ADDENDUM #1

Date:	02.25.2014	Addendum No:	1
Project:	York General Health Care Services Hospital Addition And Remodel	Project No:	24902
To:	Jake Kulhanek	Firm:	Sampson

2 WALL SECTION
1/2" = 1'-0"

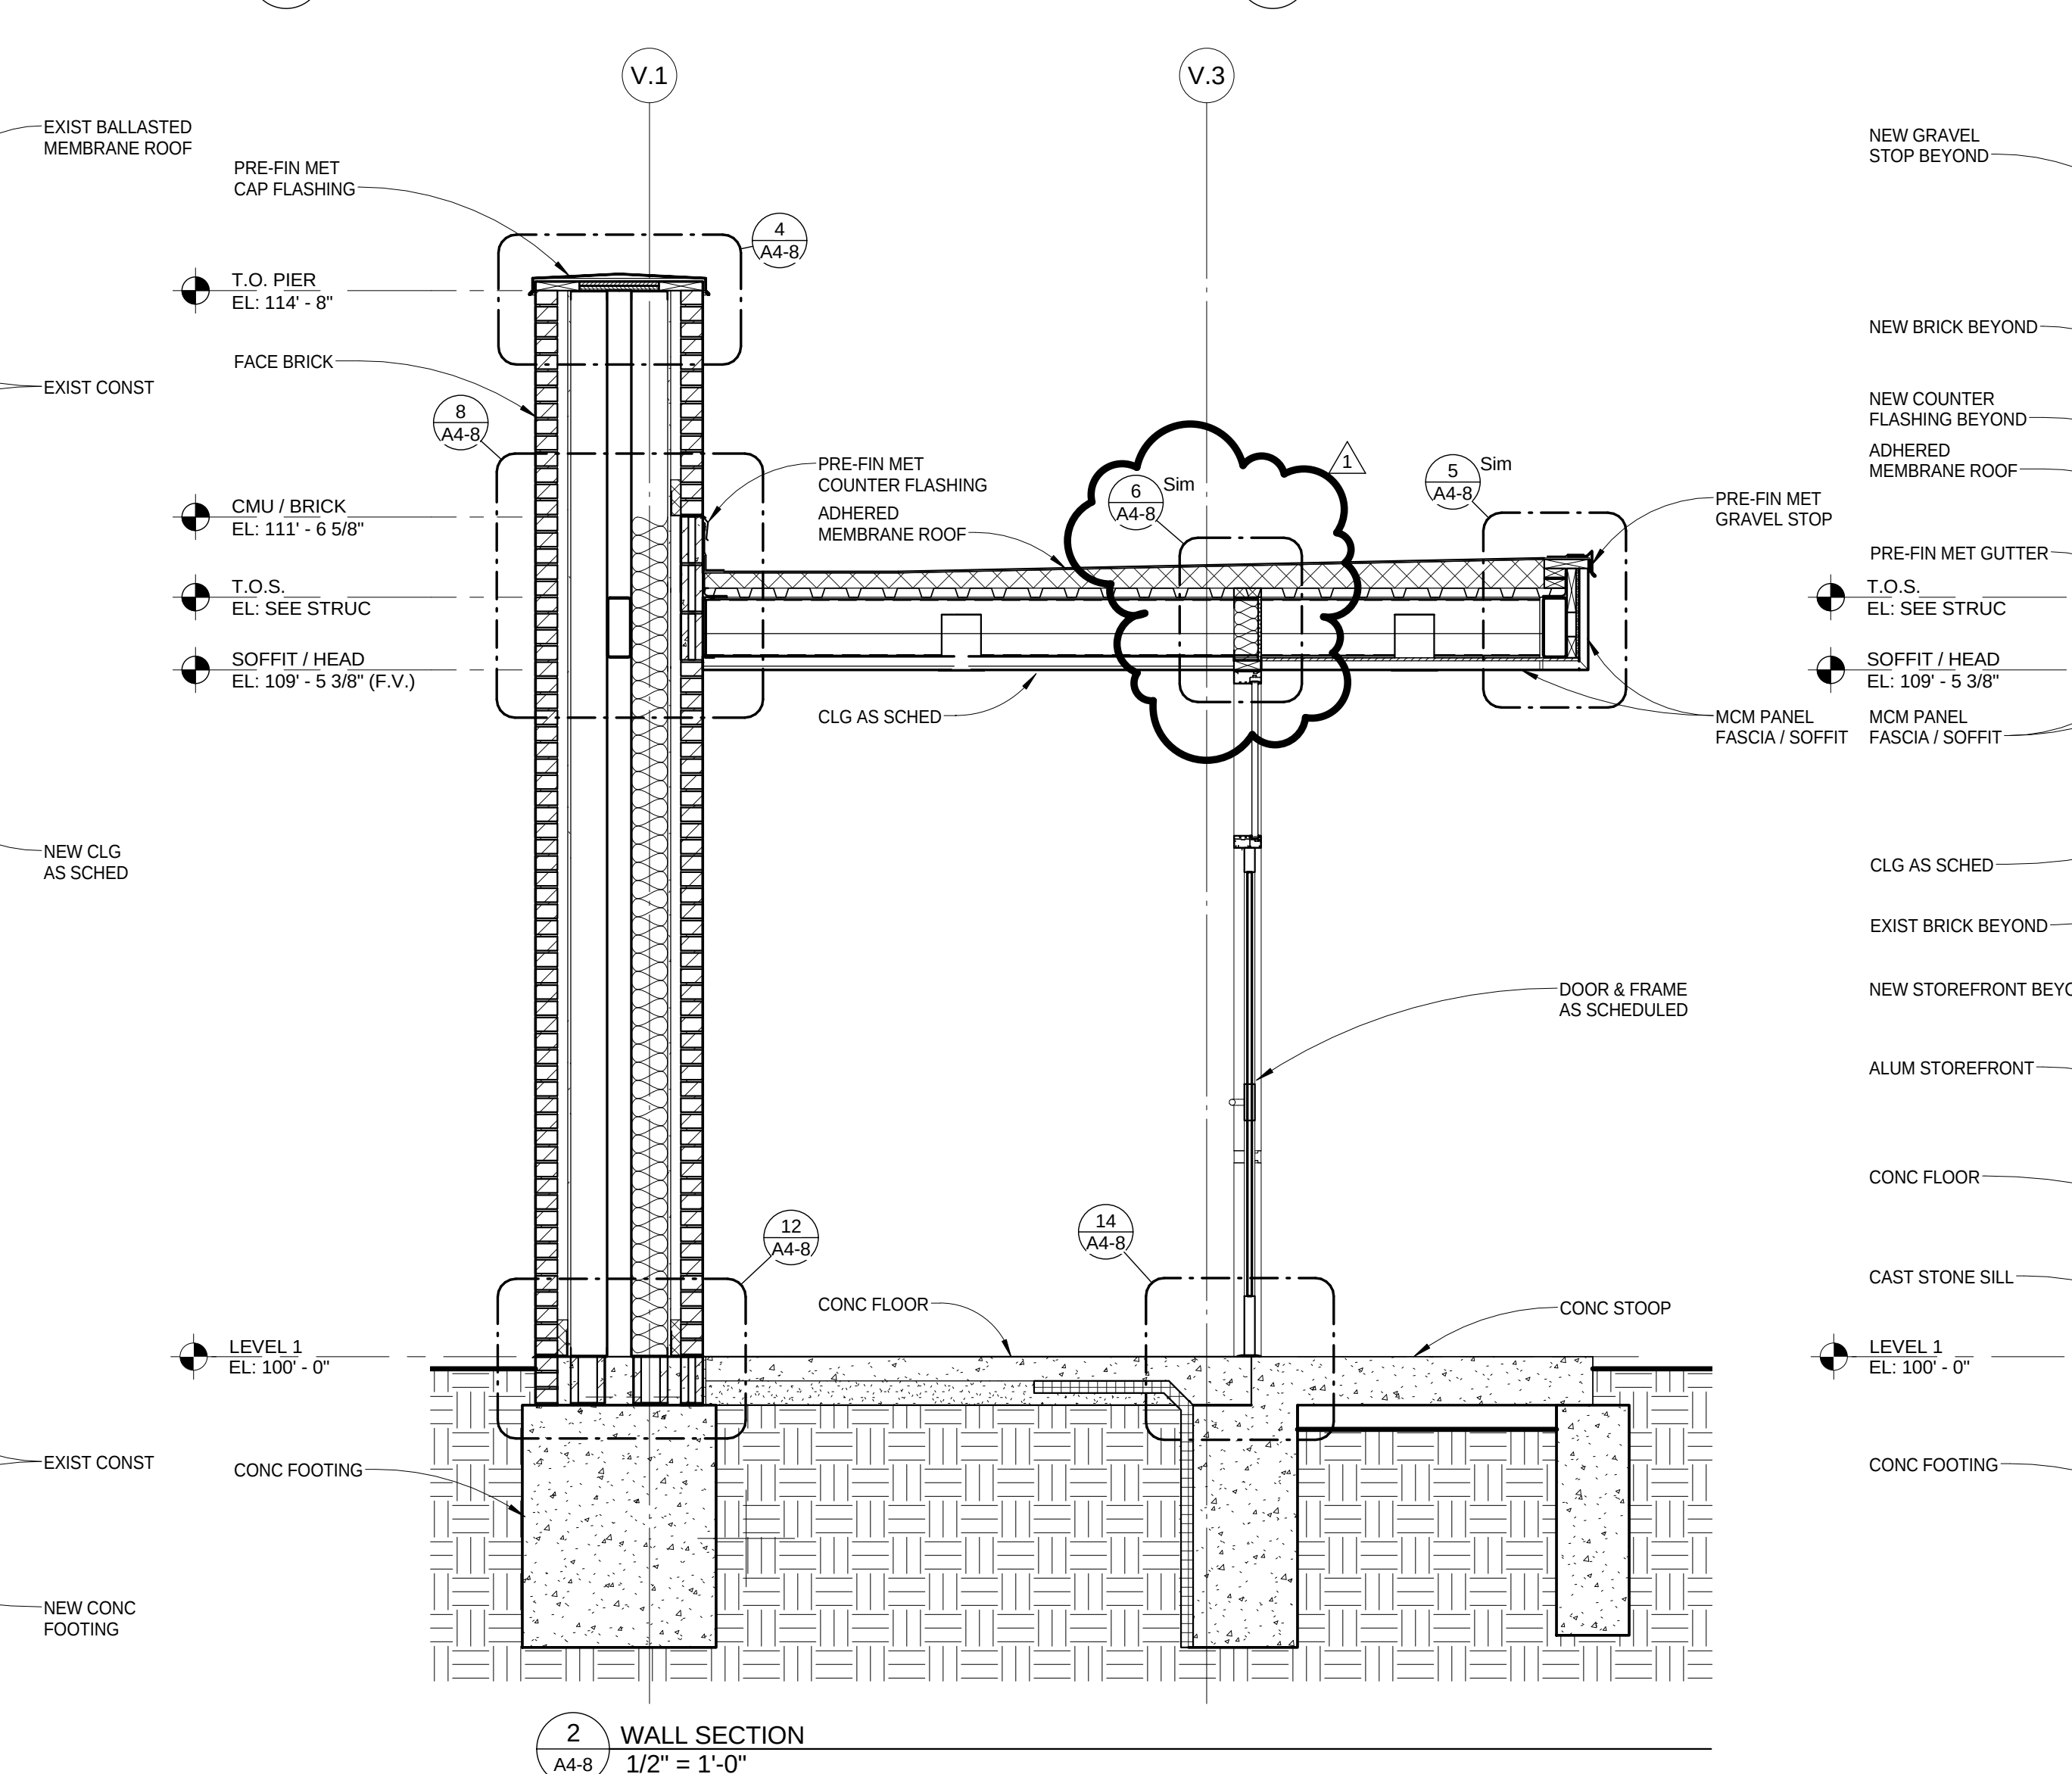
- d. Detail 14/A4-8. Add perimeter insulation similar to detail 13/A4-8.
 - e. Section 2/A4-8. Add metal stud wall above storefront similar to section 3/A4-8. Add detail reference “6/A4-8 Sim” to head of storefront.

3 WALL SECTION
1/2" = 1'-0"

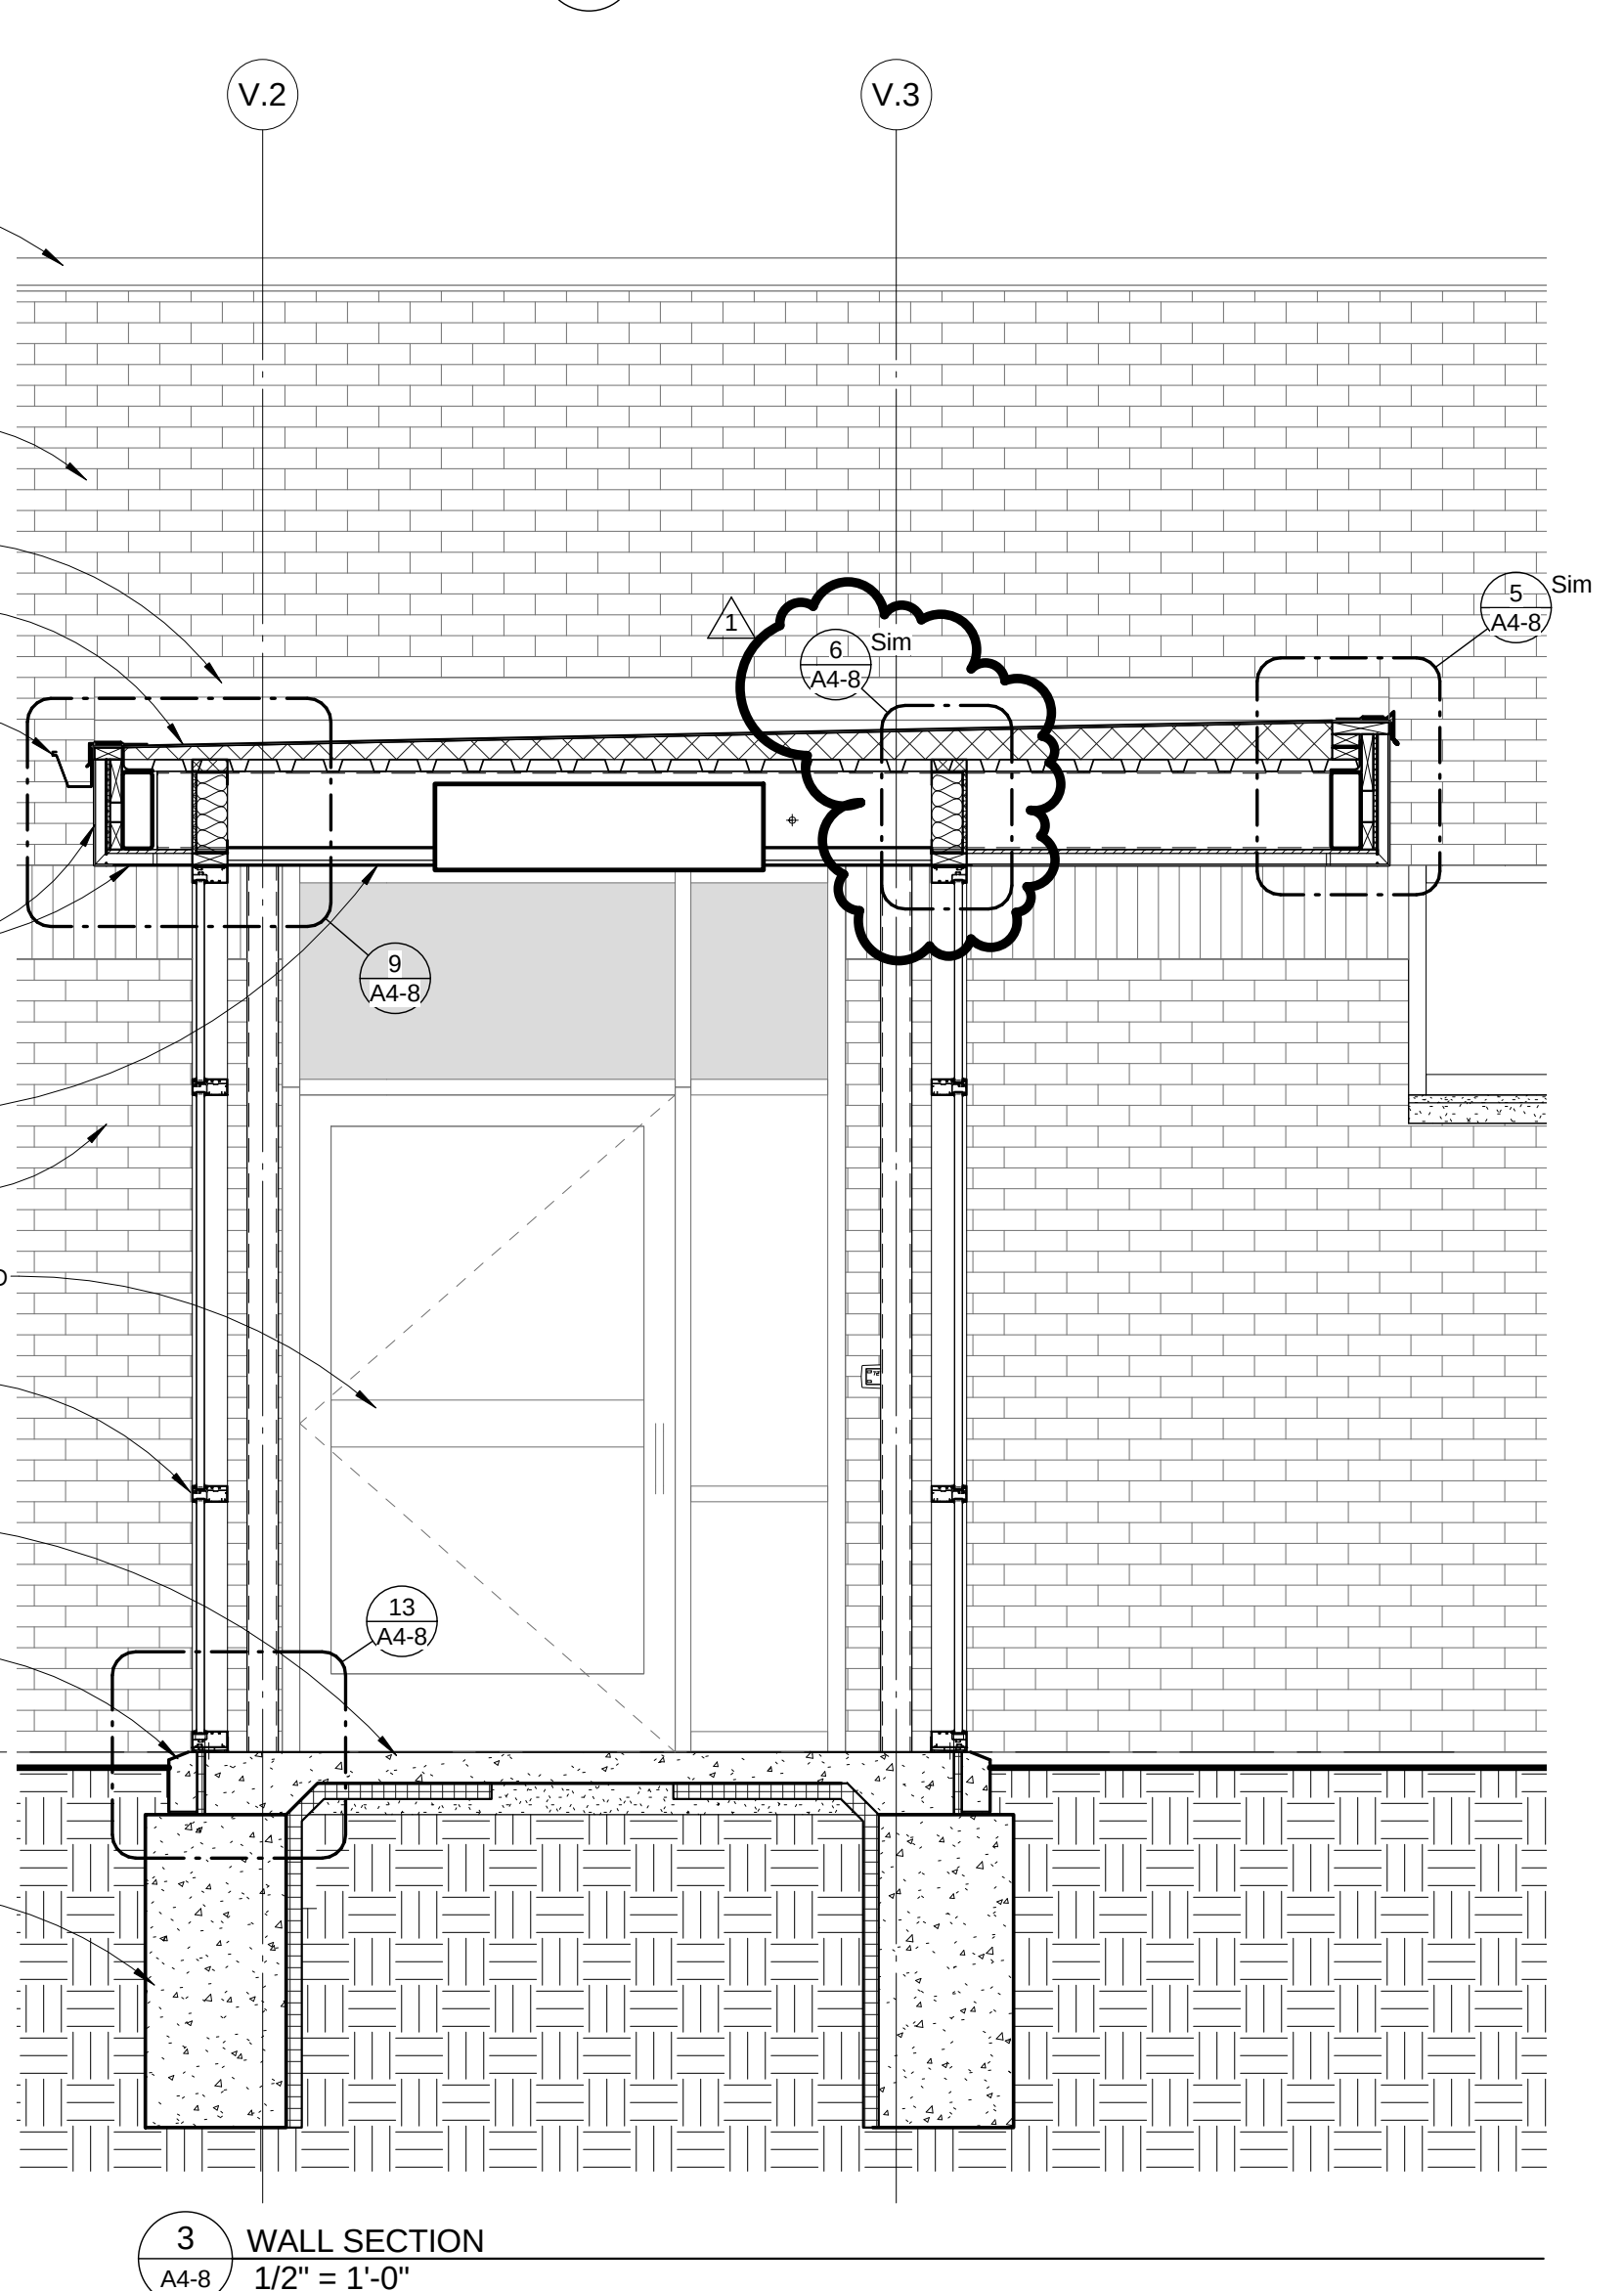
- f. Section 3/A4-8. Add detail reference “6/A4-8 Sim” to head of storefront at grid “V.3”.
- 20. Sheet A4-10, WALL SECTION DETAILS. (Reissue in its entirety):

Sheet Title:
**REFLECTED
CEILING PLAN -
AREA "A"**

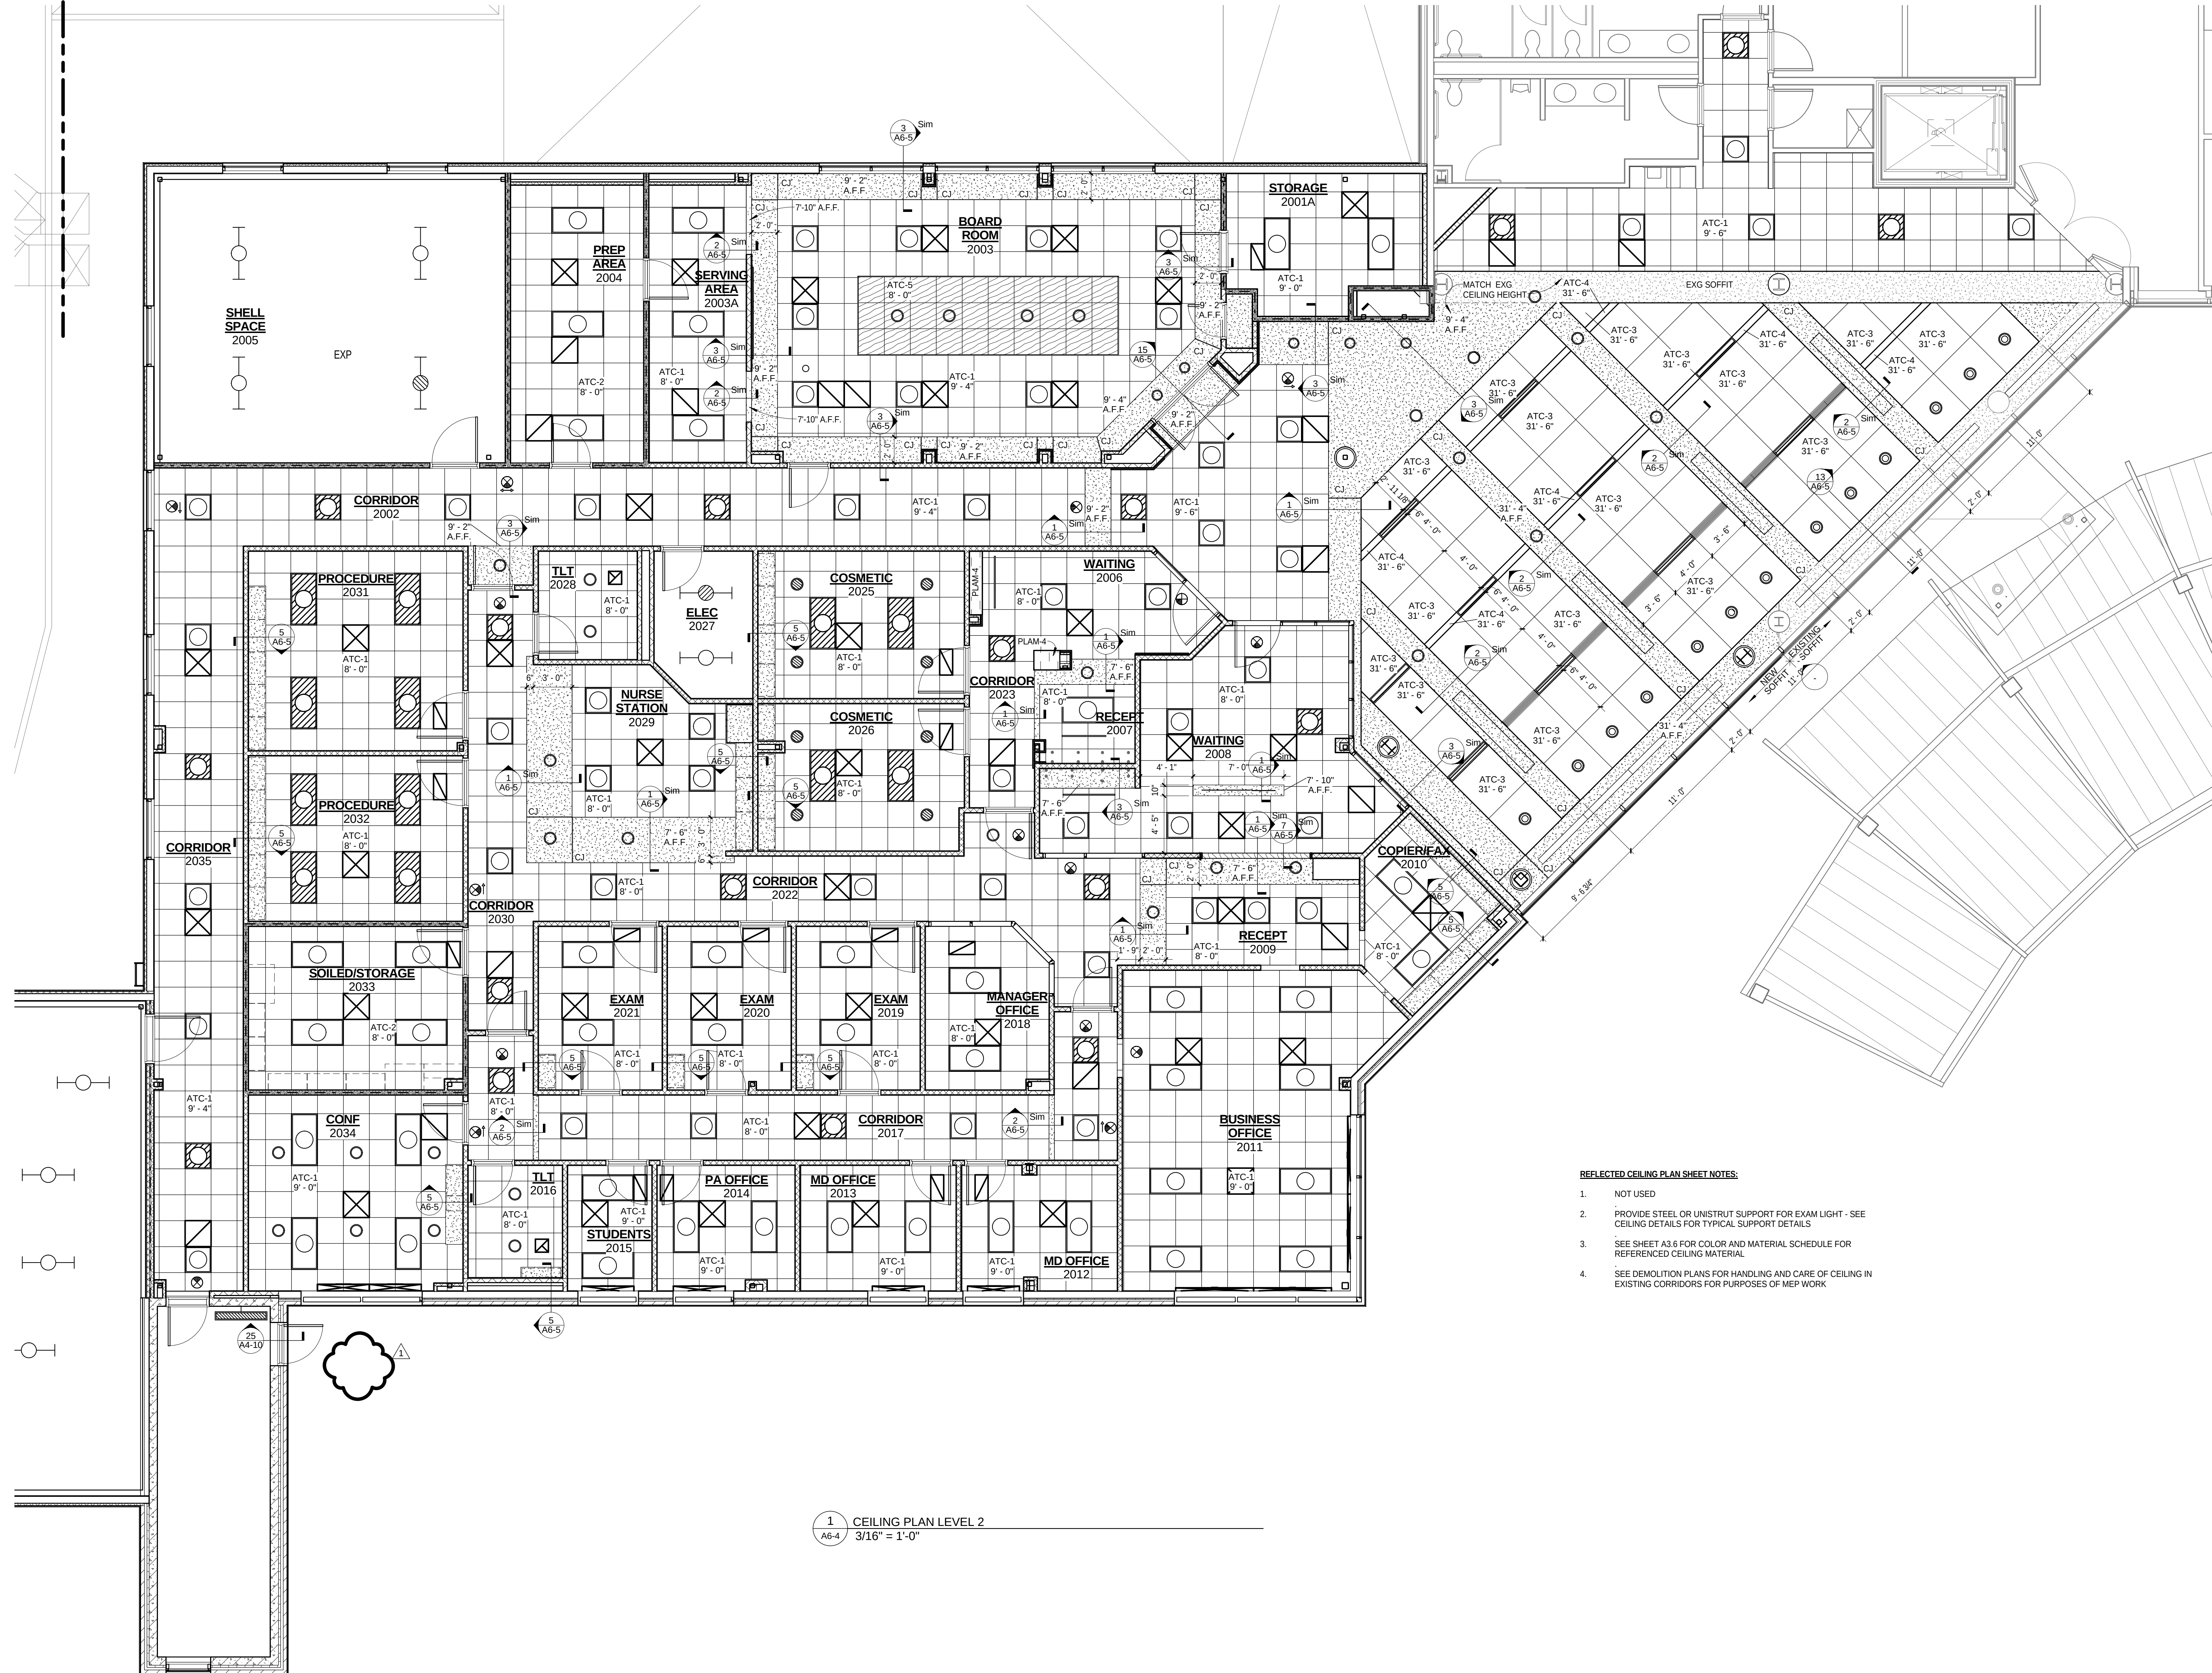
- a. LOBBY ENTRANCE 1300. Delete soffit label "P-A 10'-4 1/4"" and substitute "MATCH EXISTING".
 - b. ALCOVE 1341A. Delete soffit elevation "8'-0" A.F.F." and substitute "7'-2" A.F.F.".

- c. ADULT GYM 1341. Add water cooler recess to east wall with GWB soffit.
23. Sheet A6-4, REFLECTED CEILING PLAN – LEVEL 2. (Reissue in its entirety):
